Date: **MAR 11 2016**
Symbol: EPC-DO-16-055
LA-UR: 16-21335
Locates Action No.: N/A

**Subject: Notification of Class 1 Permit Modification Construction Updates for the Technical Area
63 Transuranic Waste Facility Container Storage Unit, Los Alamos National Laboratory
Hazardous Waste Facility Permit, EPA ID # NM0890010515**

**Class 1 Permit Modification
Construction Updates for the
Technical Area 63 Transuranic Waste Facility
Container Storage Unit,
Los Alamos National Laboratory
Hazardous Waste Facility Permit**

Figure 1: TWF Utilities Figure (LANL, 2012)

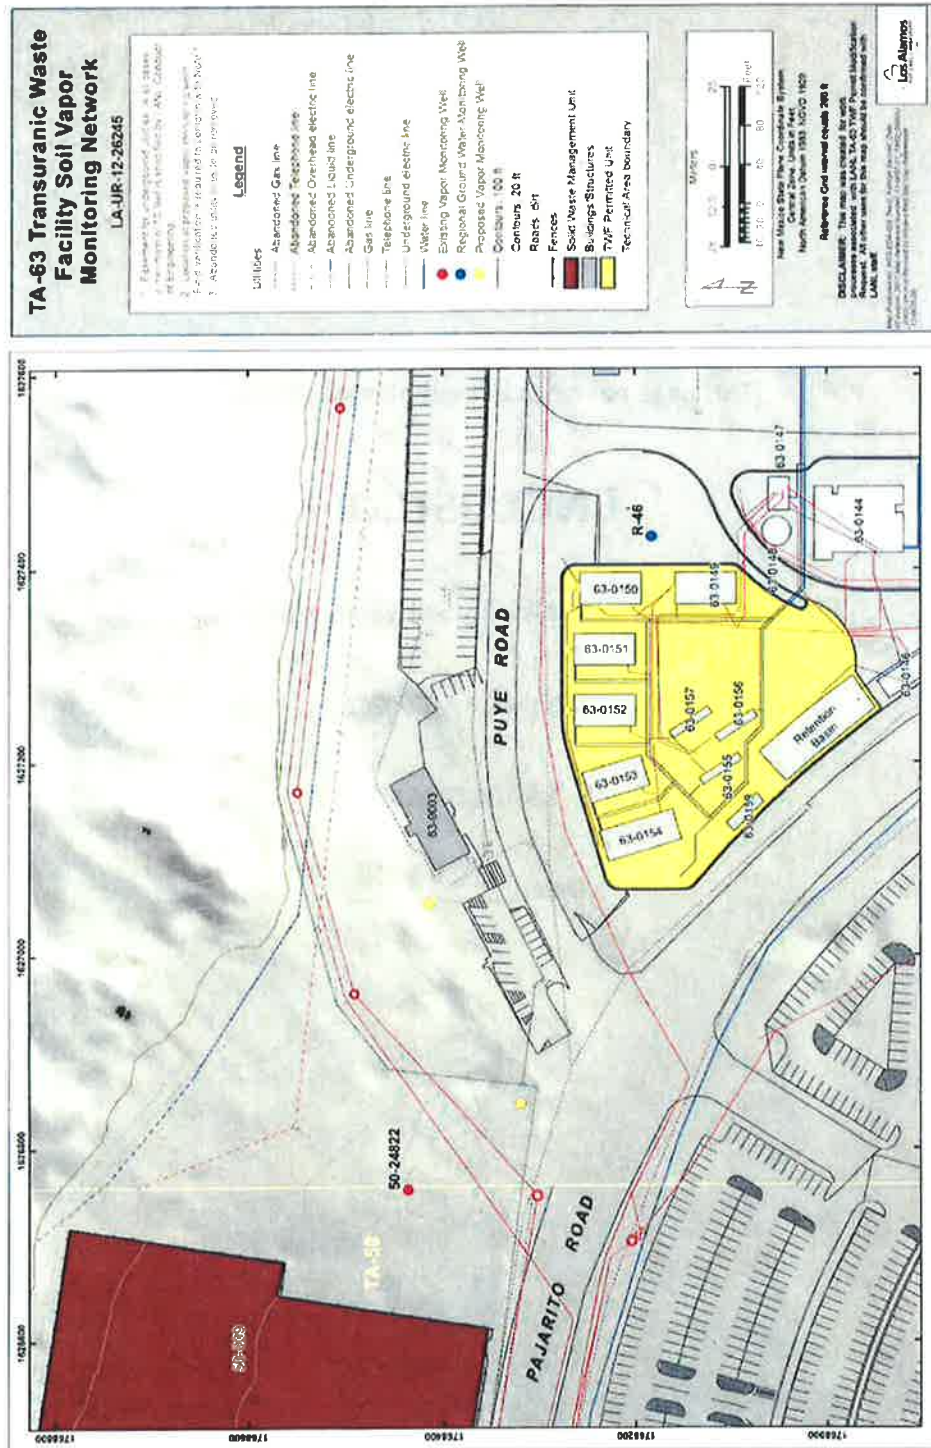
As originally designed and described in Permit Attachment A, *Unit Descriptions*, the TA-63 TWF had a fire suppression system including a 150,000 gallon tank and electric and diesel powered fire pumps to distribute water to automatic sprinkler systems in the storage buildings. The design capacity for the fire water storage tank was increased to 200,000 gallons and the tank has been constructed to that capacity. This represents a positive 25% increase in water available for a fire event but does not impact the design factors that were used to calculate the capacity for the retention basin (see Permit Section A.6.5).

This design change affects Permit Attachment A, *Unit Descriptions*, Section A.6.8, *Required Equipment*. The section states that “...Water will be supplied via the 150,000 gallon tank north of the Operations Support Building with a combination of electric and diesel powered fire pumps to distribute water to automatic sprinkler systems in the buildings...” The sentence has been revised to say “Water will be supplied via the 200,000 gallon tank north of the Operations Support Building with electric fire water pumps backed up with a diesel generator to distribute water to automatic sprinkler systems in the buildings.” (See Attachment 8).

Figure 56

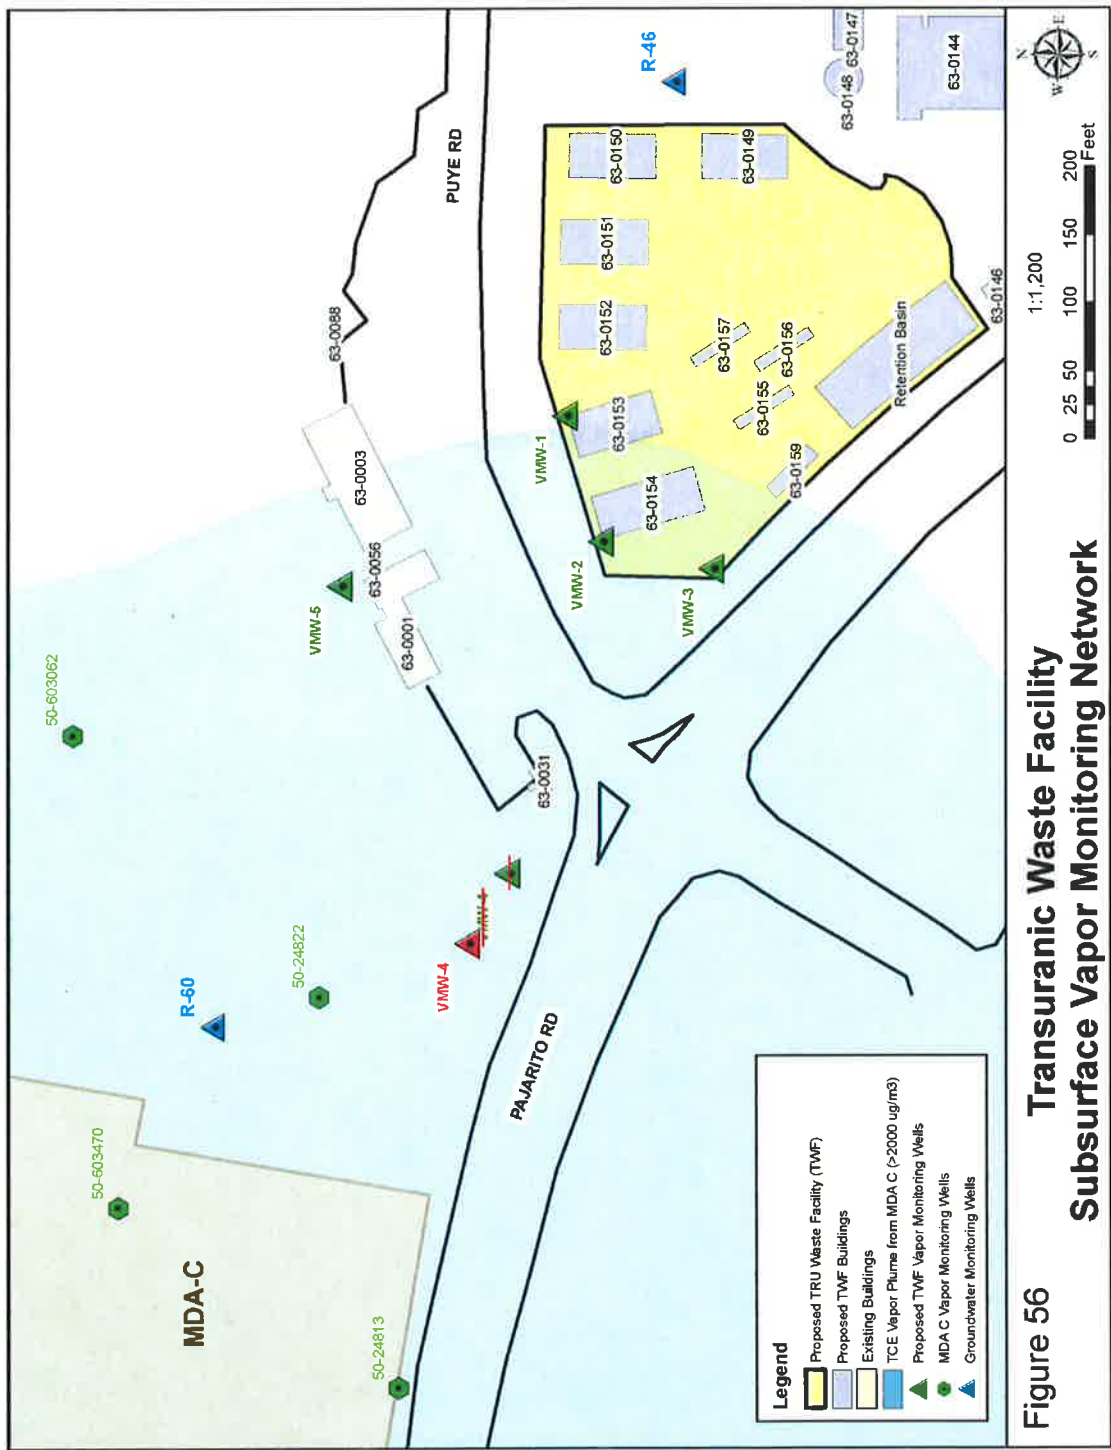
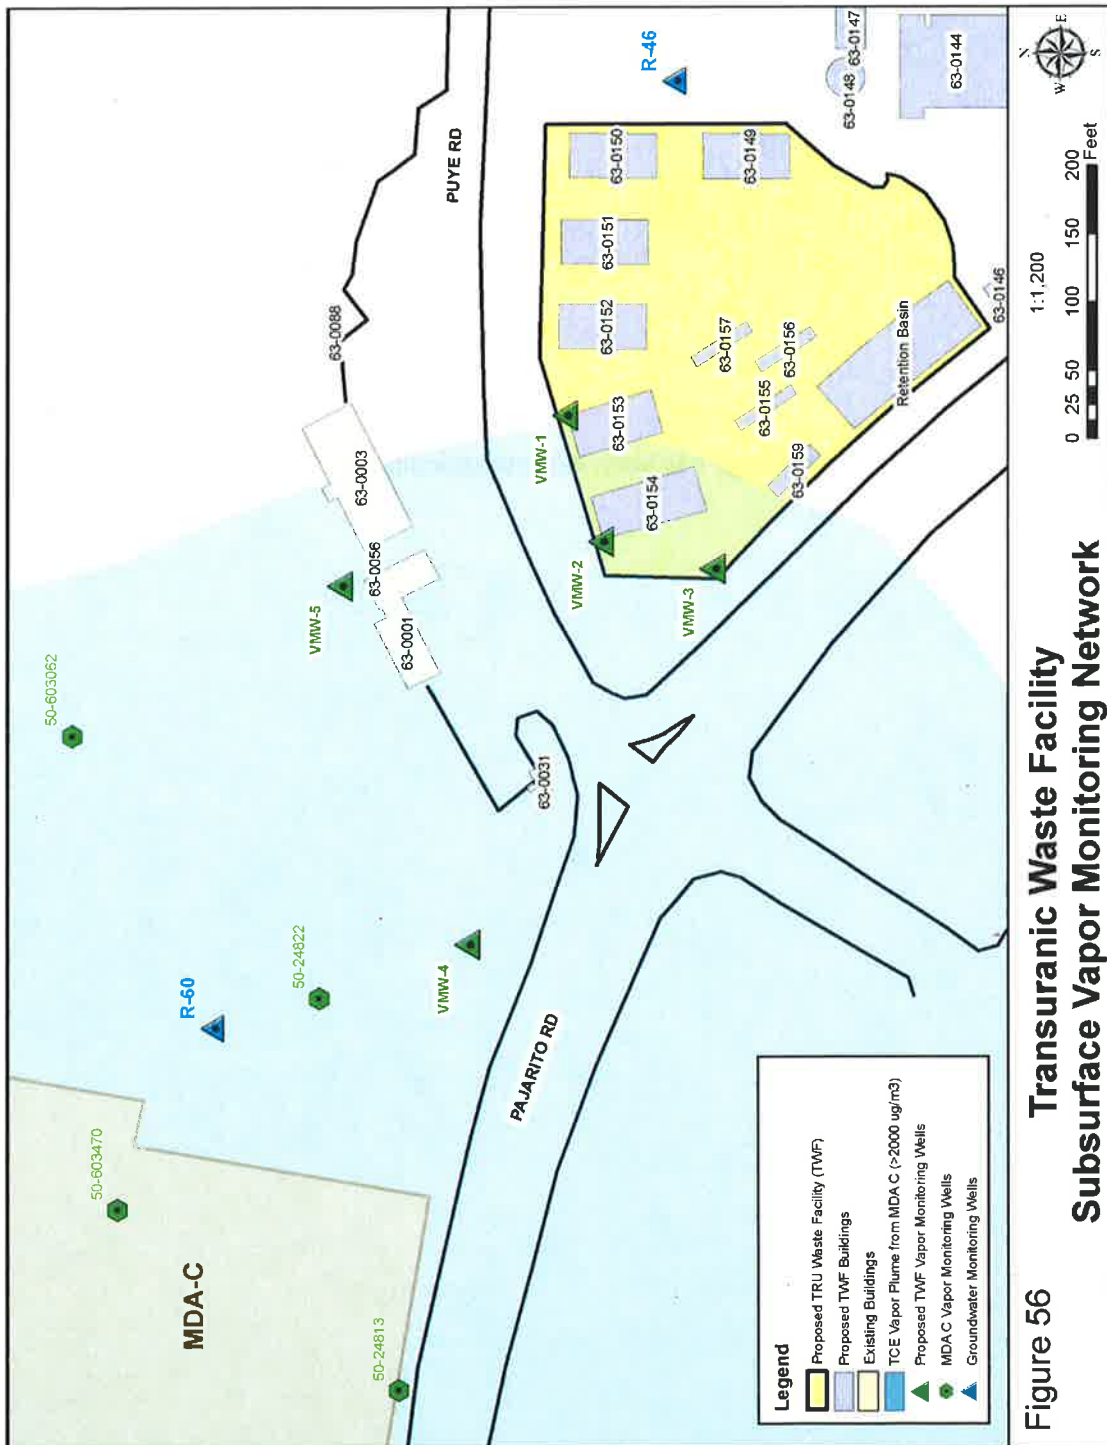
The *TA-63 Transuranic Waste Facility Soil Vapor Monitoring System Report*, submitted to NMED-HWB on October 29, 2015, includes a variance discussion at Section IV that describes a minor change in the location of the VMW-4 monitoring well. The location originally proposed for the monitoring well was situated in close proximity to an underground natural gas delivery line. This proximity is illustrated in a supplemental information letter submitted to NMED on December 6, 2012 (LANL, 2012). The figure included with the submittal shows that the proposed well location northwest of the TA-63 and the Pajarito and Puye Roads intersection is close to a gas line junction and an abandoned line (see Figure 1 of Attachment 9 of this submittal). LANL well siting procedures require a set-back to prevent accidentally drilling into utility services. The originally proposed location is also near a large drainage swale and the drilling site was relocated to the northwest to get better access to an existing dirt road for the drilling rig.

The direction of the move places the monitoring well a small distance closer to the source of the vapor plume being monitored. As included in the October 29, 2015 report, the soil vapor concentrations obtained in the first sampling event for the well were significantly below the soil gas screening levels included in Permit Section 3.14.3, *Subsurface Vapor Monitoring*. In addition, the nature of the VMW-4 sampling well with the position of the source for the vapor plume indicates the position is more closely identified with being a “sentry” location for early warning of soil vapor presence rather than an indicator of the effect of soil vapor emissions on the actual waste management activities at the TA-63 TWF storage buildings. That function is met by the soil vapor monitoring wells VMW-1 and 2 which were installed next to the storage area work buildings. VMW-4 is also not identified as a representative well for determining the effect of vapor emissions near a utility corridor as indicated for VMW-3 (NMED, 2013). The VMW-4 sampling depths of 25 and 60 feet are unlike the 5 foot sampling depth for VMW-3 and are deeper than utility corridor installation depths. For these reasons, there does not appear to be a significant effect associated with the location change.

This design change affects Figure 56 of the approved Permit. Figure 56 has been revised to account for the change in location of the VMW-4 soil vapor monitoring well. (See Attachment 9).
